Doors layout amendments &
Integration of Back Painted Glass on the East Elevation
Wuk_SK_PL_005

The following paragraphs set out the proposed changes and design rationale in more detail as an addendum to the approved Urban Design Report.

Integration of Louvres for future tenants within façade reveals
on the West Elevation
Wuk_SK_PL_010

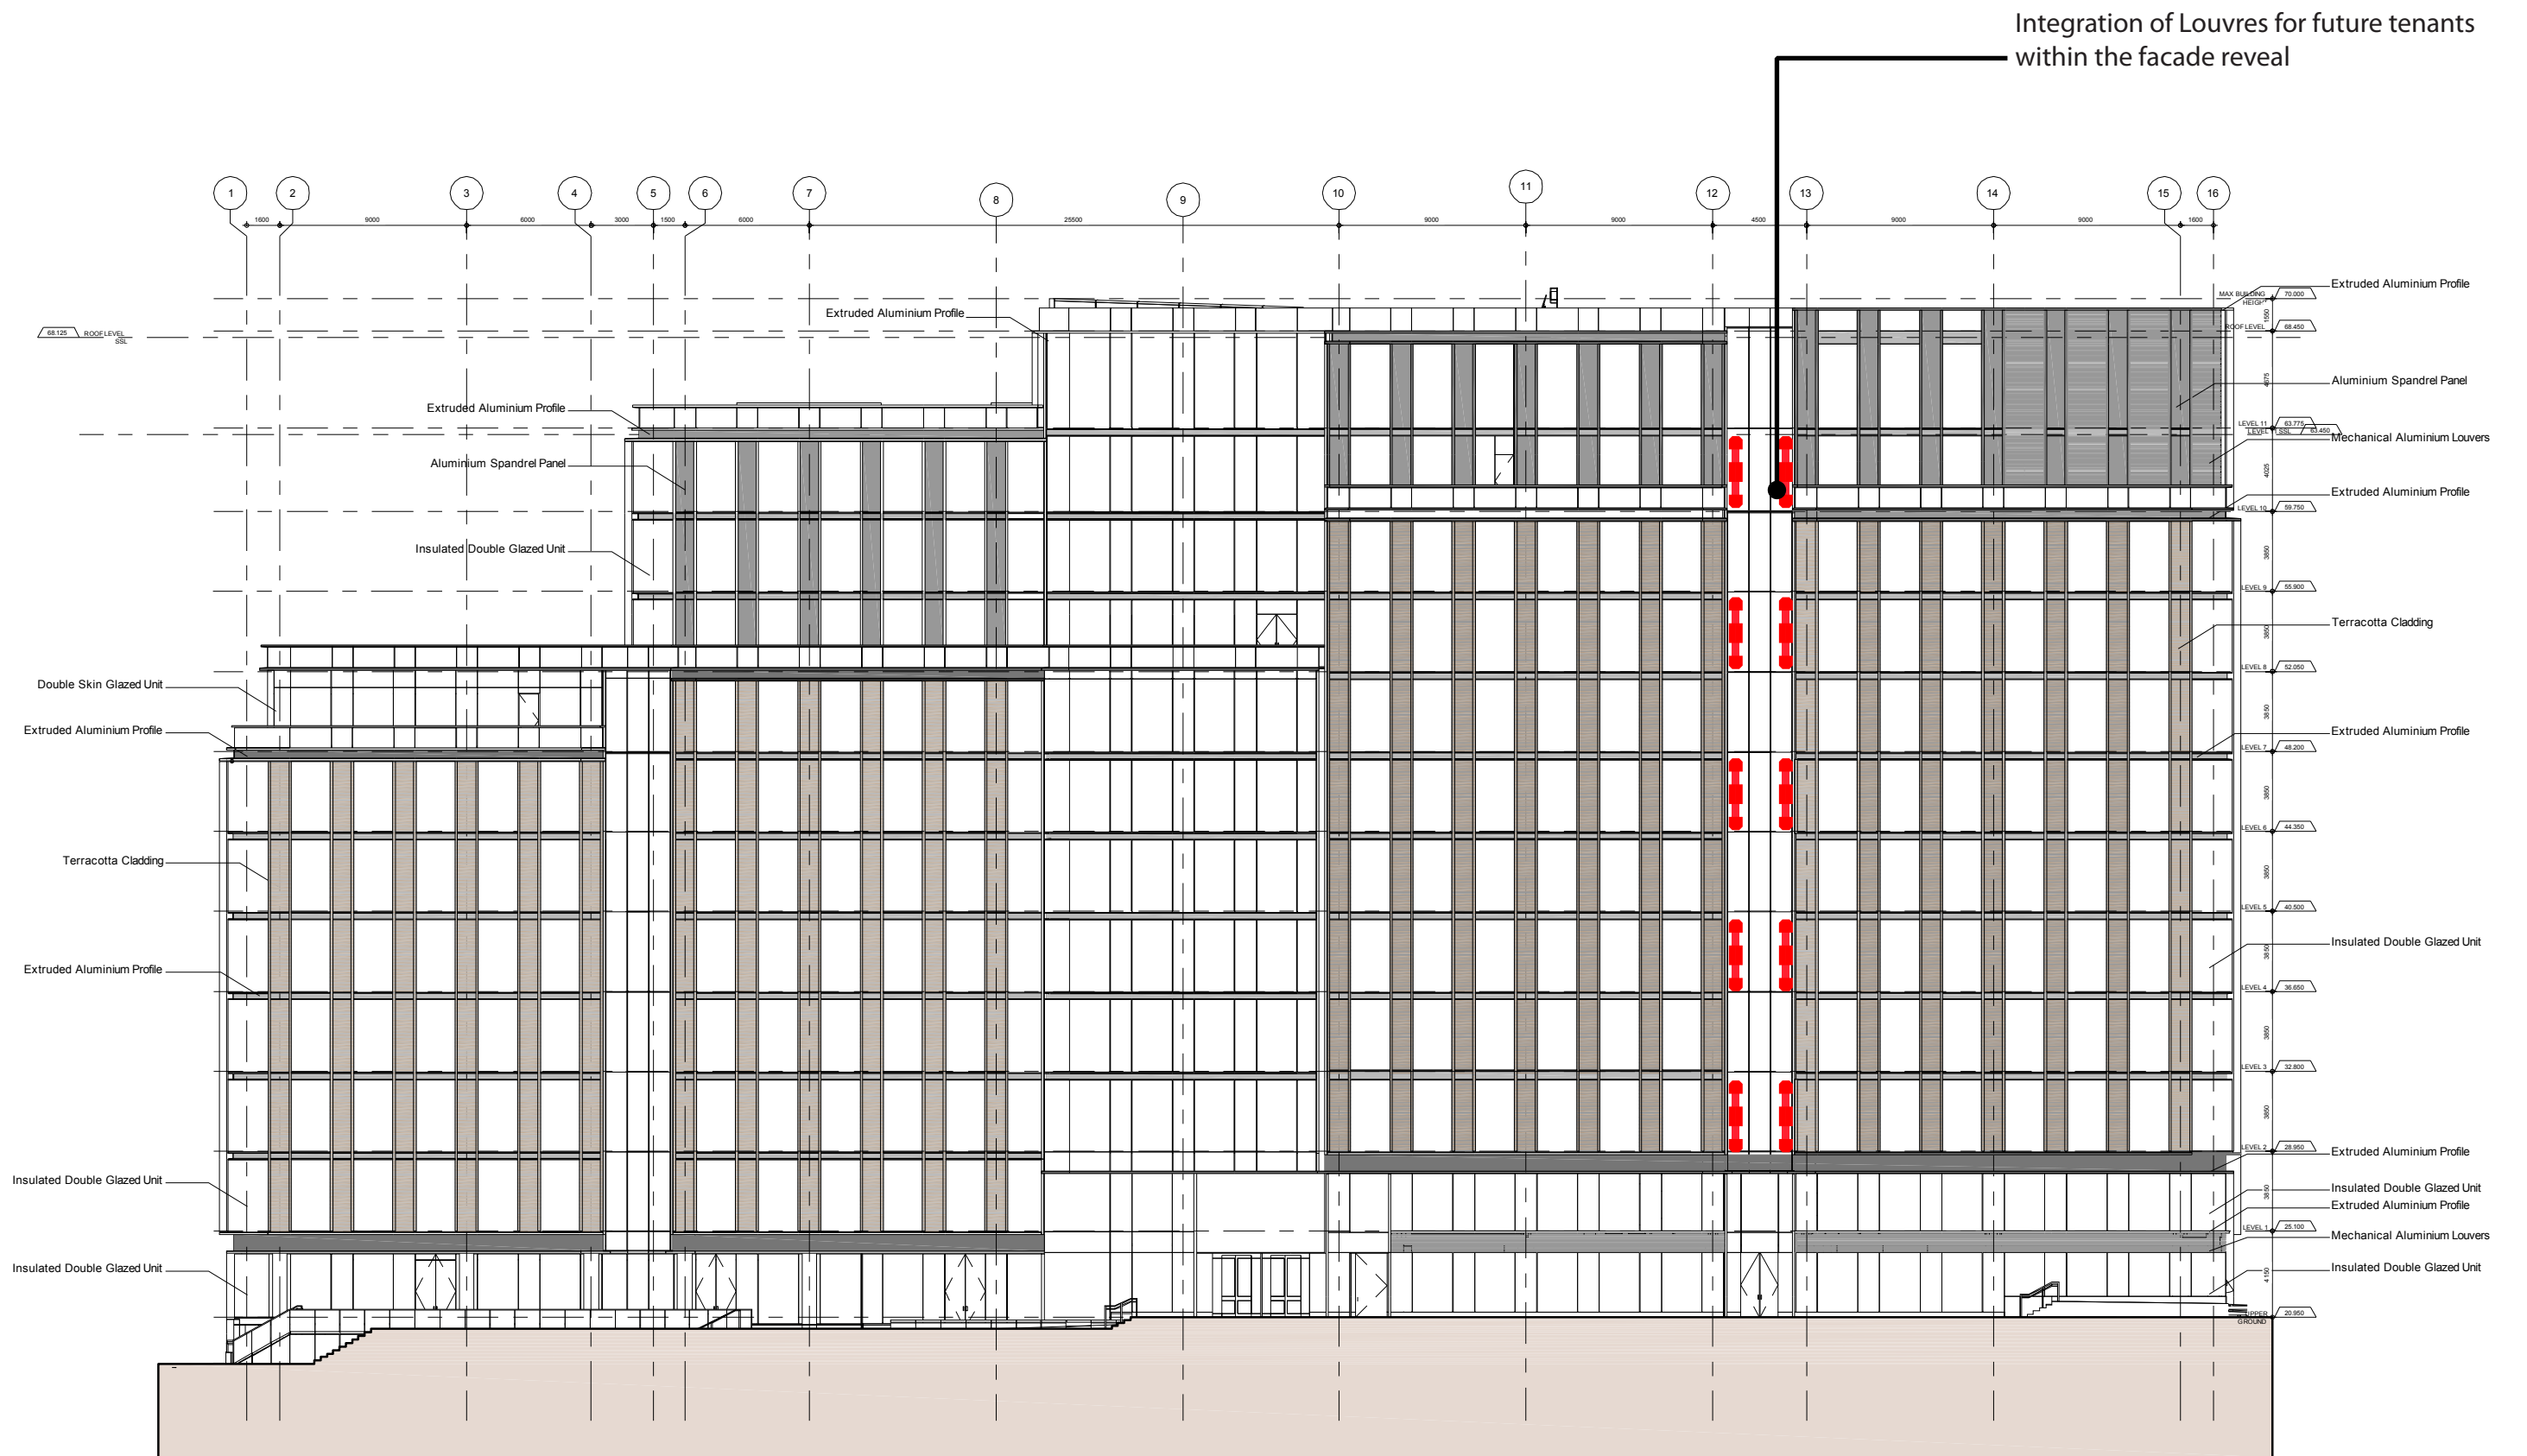
Some areas of louvres to facilitate future fit out works have been integrated with the reveals of the facade. The detail consists of some black anodised architectural louvres matching the finish of the adjacent panels.
